**The Knowle, Sidmouth – Response to Viability Review undertaken by Plymouth City Council**

**PEGASUS LIFE  
THE KNOWLE, SIDMOUTH**

**REPORT ON MACE VIABILITY ASSESSMENT COST REVIEW**

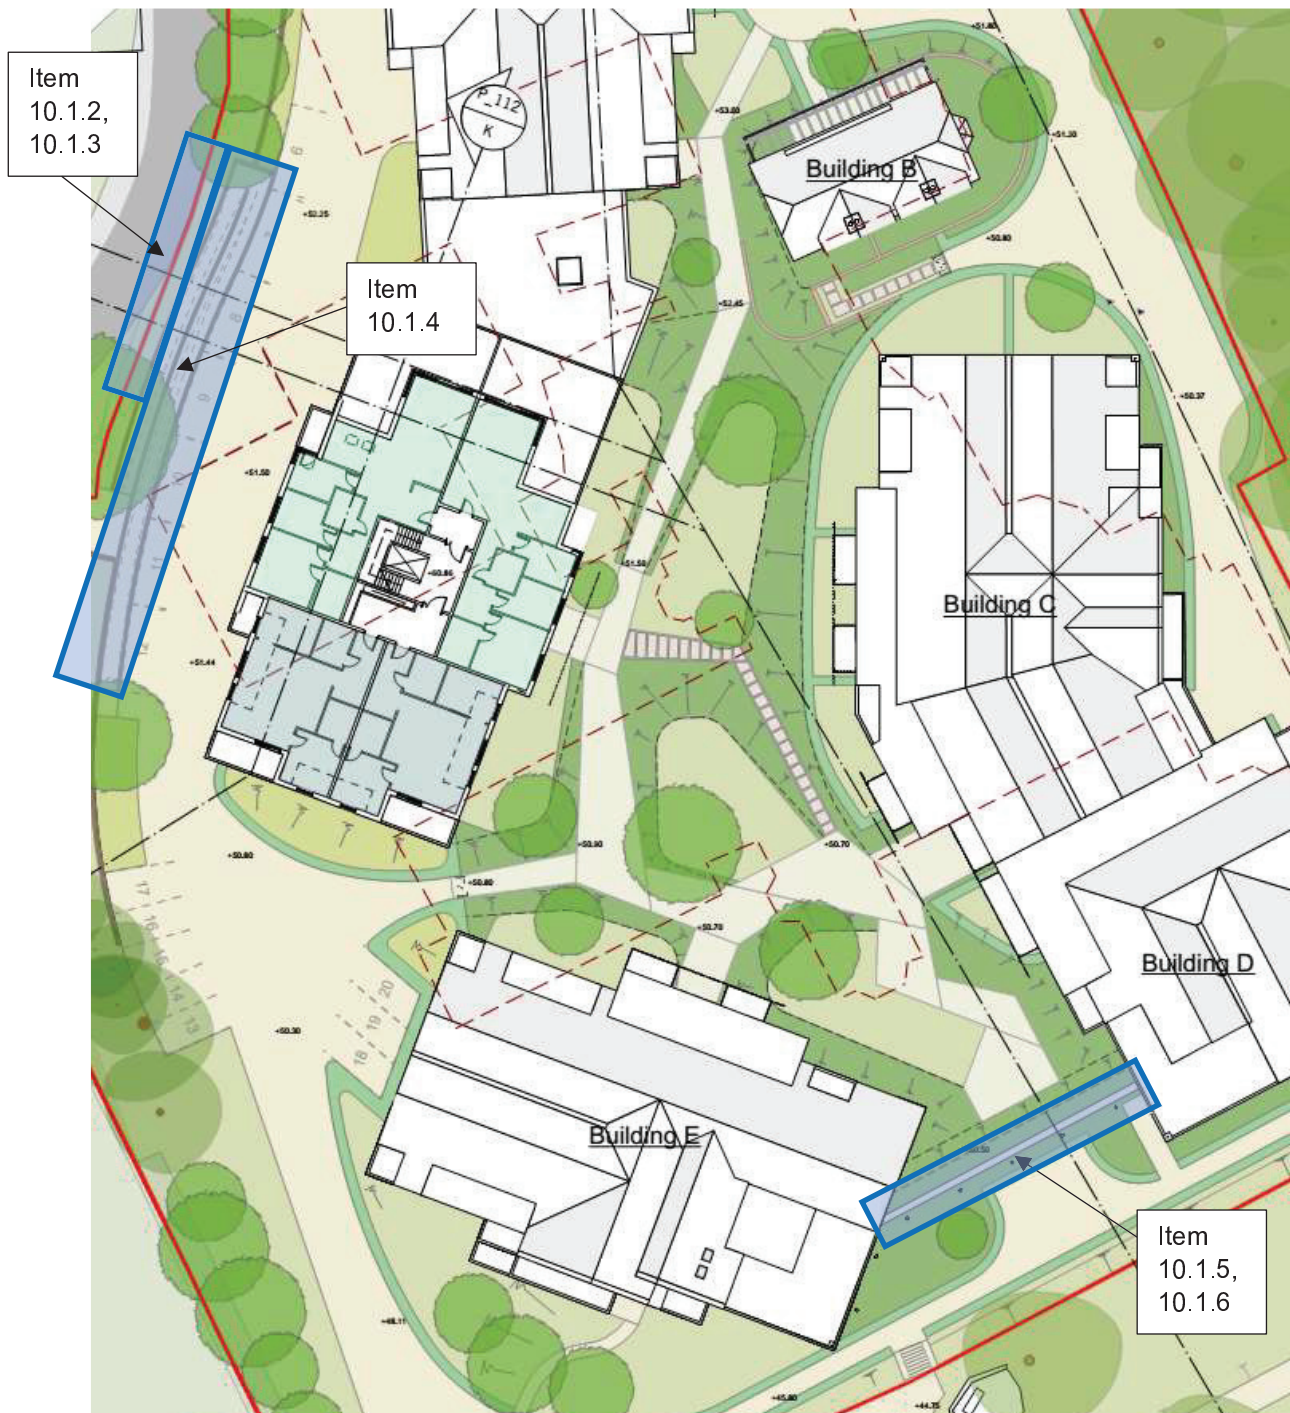
- 4.2.21 Item 11.2 (Main Contractors Preliminaries): A monthly cost has been applied for preliminaries as we believe that it more accurately reflects the costs associated with managing construction activities than a percentage uplift on the cost of construction works. It is likely that this project will be split into two work areas based on the site layout and constraints, and so a figure of [REDACTED] is considered reasonable for the value, duration, buildability challenges and quality requirements of a high quality retirement project. The typical OH&P mark-up on projects of this type is [REDACTED], but we have assumed a slightly lower rate here [REDACTED] to reflect the larger project value. We would therefore propose no change to the current allowances.
